REQUEST for PROJECT CHANGE ('RPC')
WOOLOOWIN WORKSITE MODIFICATION

**Report on Principal Construction and Community aspects associated with the
RPC**

**Queensland Department of Infrastructure and Planning
(as agent for the Coordinator-General)**

G M Peck & Associates Pty Ltd
Author: G M Peck

Figure 3.4.a Underground sequencing logic to achieve seven (7) Roadheader workfronts from original Kedron & Chalk St access points plus proposed Rose Street shaft addition.

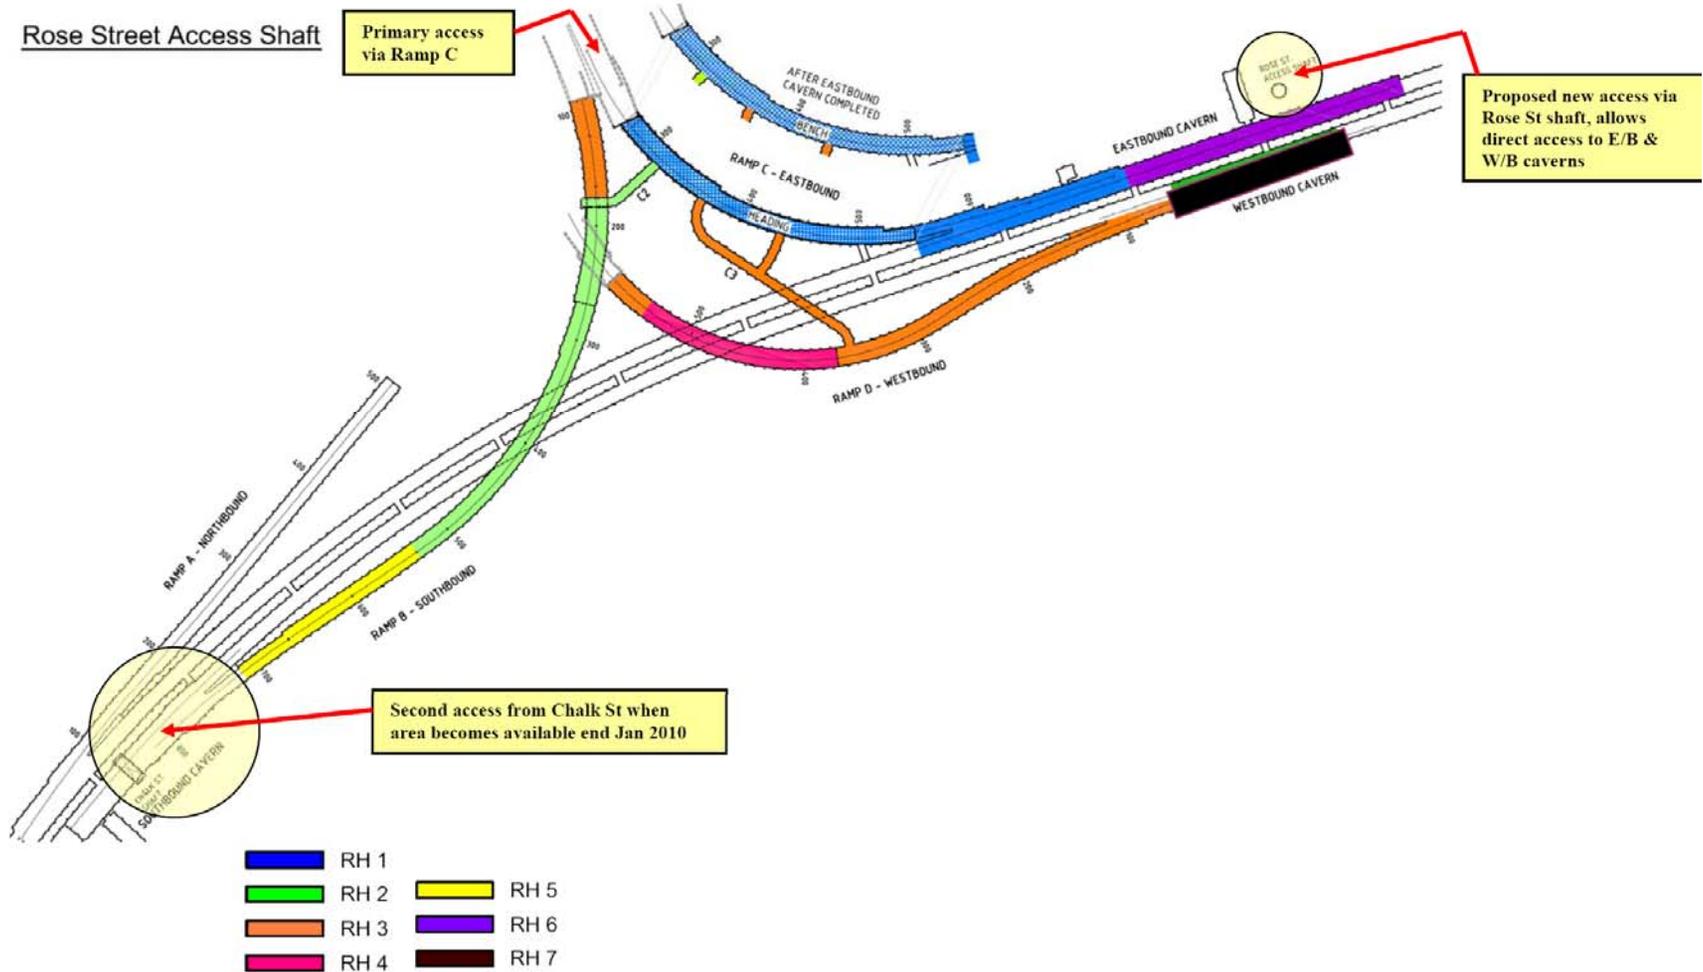
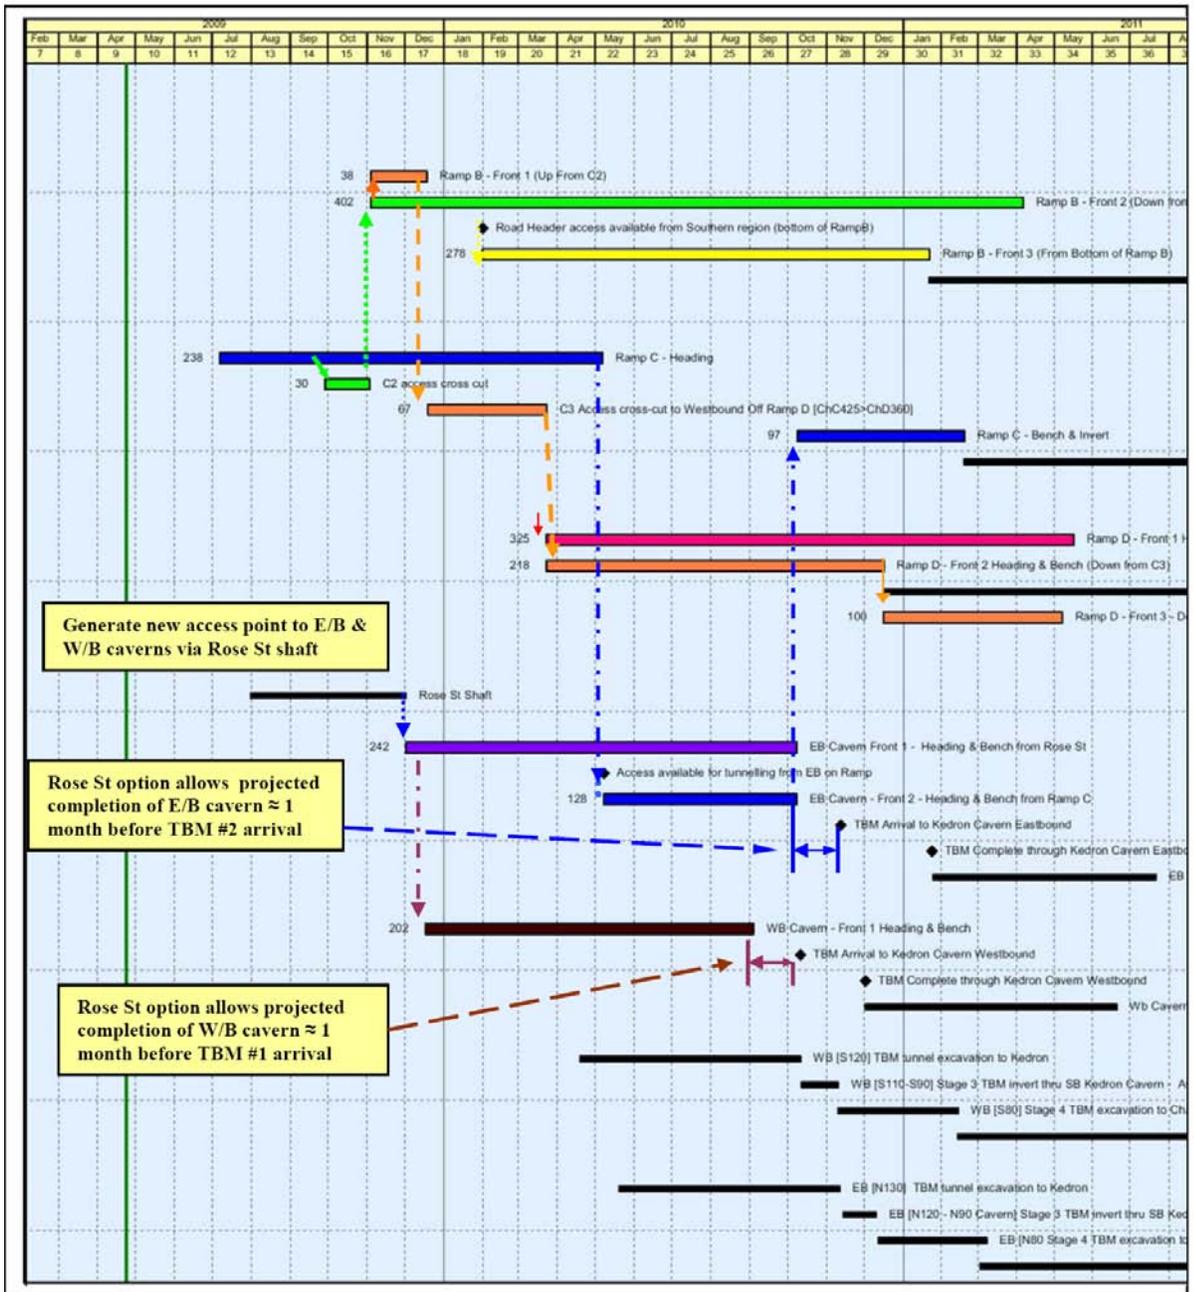
The work sequence logic and program outcomes resulting from the Rose Street shaft option are reproduced in figures 3.4.a and 3.4.b following.

[note that the sequence diagram included in the RPC, Appendix -1 for this option, Appears to have incorrectly coloured the segment of Westbound cavern work undertaken by RH 7. The diagram of Figure 3.4.a has rectified this perceived error.]

Despite delays ranging up to 7 months for the Ramps, completion of the critical E/B and W/B caverns without delaying the two TBMs allows rescheduling of other work to meet the original projected completion date for the Airport Link.

Figure 4-4: Daily Excavation Rates

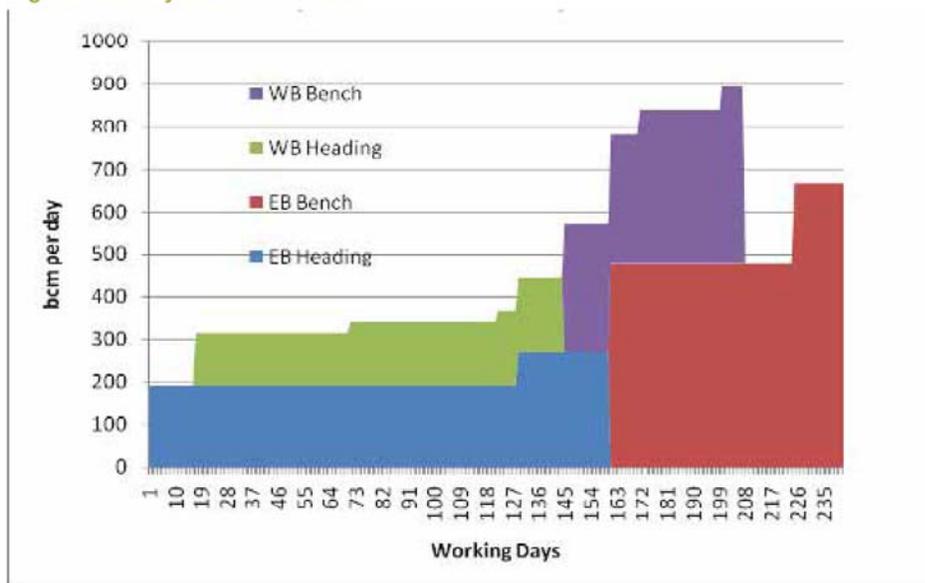
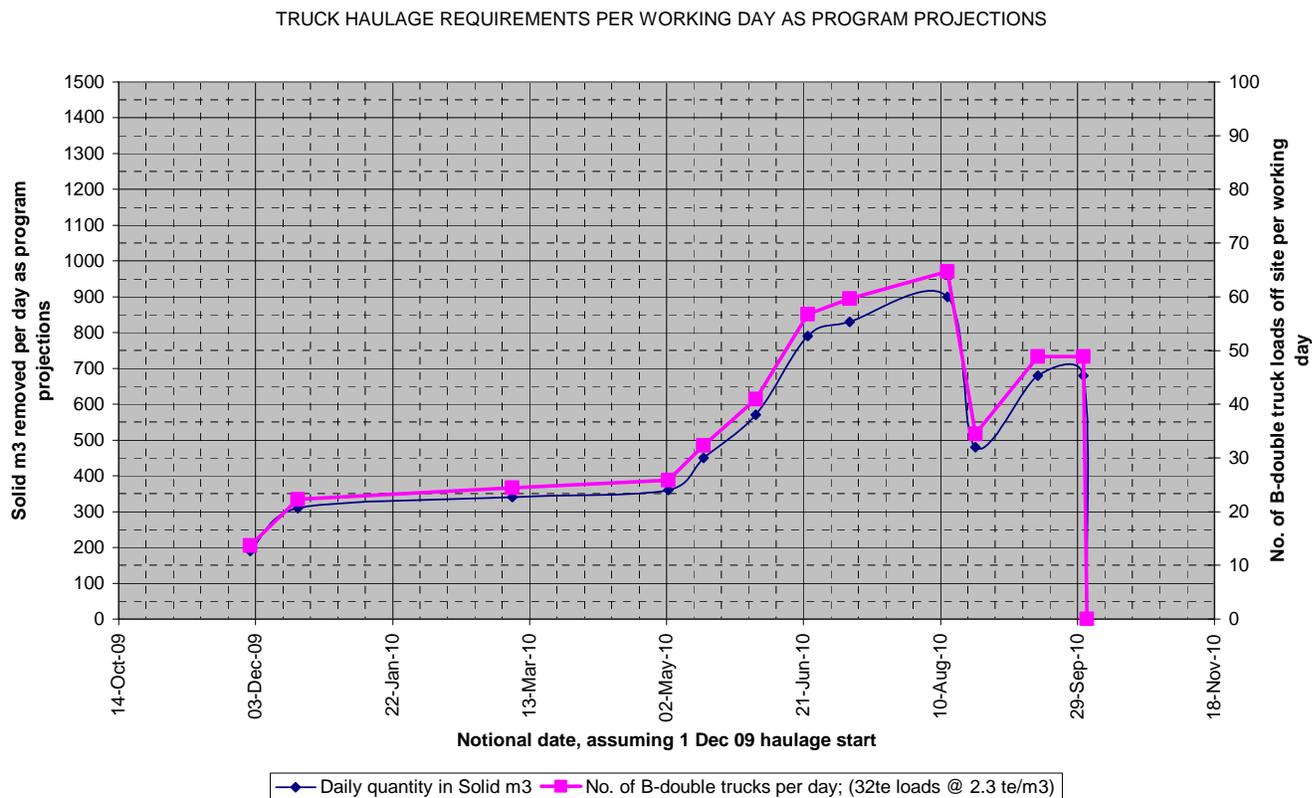
Adopting 2.3 te/m³ as the relevant figure, Figure 4-4 has been used to produce a chart of both volumes by period and truck loads by date period, as below. Date periods are based on the Rose street shaft program included in the RPC and reproduced section 5 above.

The maximum daily haulage amounts to about 65 trucks. Assuming the RPC haulage window of 06:30 to 18:30, this equates to one B-double truck entering and leaving the site on an average 11 minute cycle. For the first six months of the shaft operation, the intensity of truck movements would be less than half this figure (about 30 loads per day, on an average 24 minute cycle). The intensity then progressively builds over the period May through June, reaching the maximum over about a 2 month period (late June 2010 to mid August 2010).

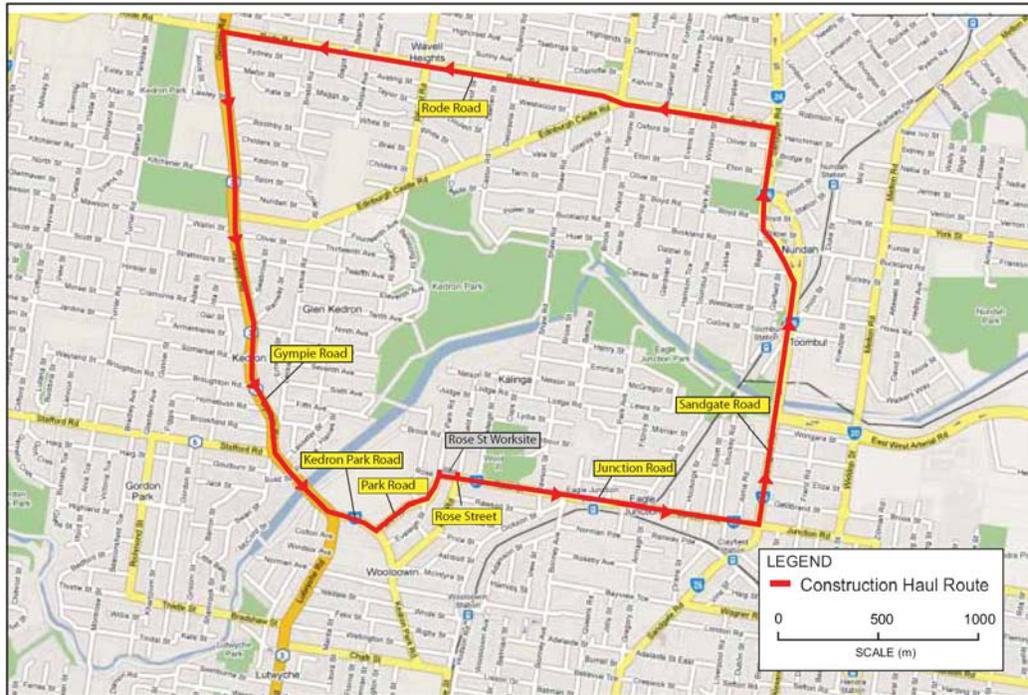
Various haulage routes have been analysed by BC/TJH. The preferred route is discussed in section 5.2.1 and identified at Figure 5-1, reproduced below.

The proposed route:

- uses State-controlled roads and arterial roads only.

- is a one-way circuit east along Rose Street and Junction Road to Sandgate Road, returning via Rode Road, Gympie Road, Kedron Park Road, Park Road, Rose Street to Kent Road.

Figure 3 – Support type comparison.

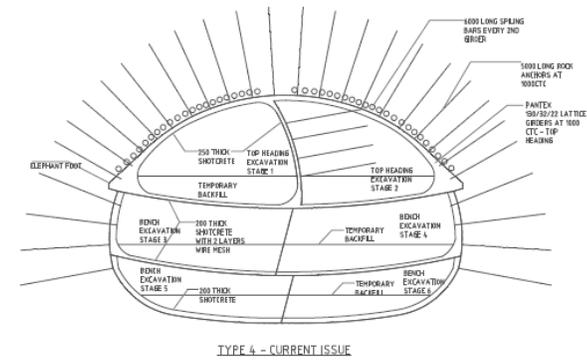
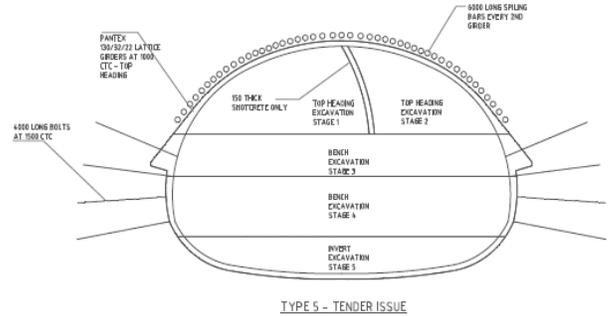
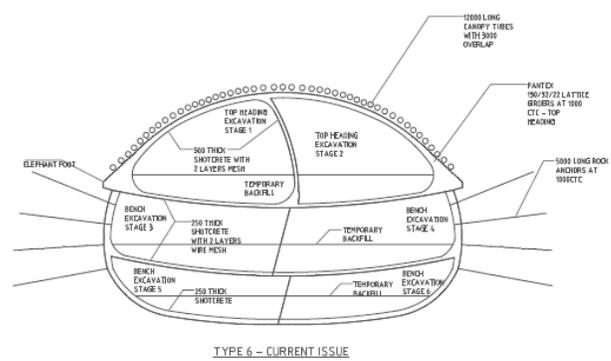
The relative complexity of the “new” support requirements compared to those originally contemplated can be appreciated by comparing the diagrams included at Appendix A-1 of the RPC for the original and current Types 4, 5 and 6 support requirements –reproduced in Figure 3 of Appendix 1 of this review.

Common underground design practice is that support complexity and cycle time for support of each face advance increases with type number increase. (The cycle time increment is non linear, so that a type 5 support may require significantly more than 5 times the duration per m than a type 1 support).

- ii. The revised “Type 5 and 6” supports are in fact significantly more complex than the original support types with the same type numbers, thus require longer times to install and further reduce the achievable rate of forward advance.
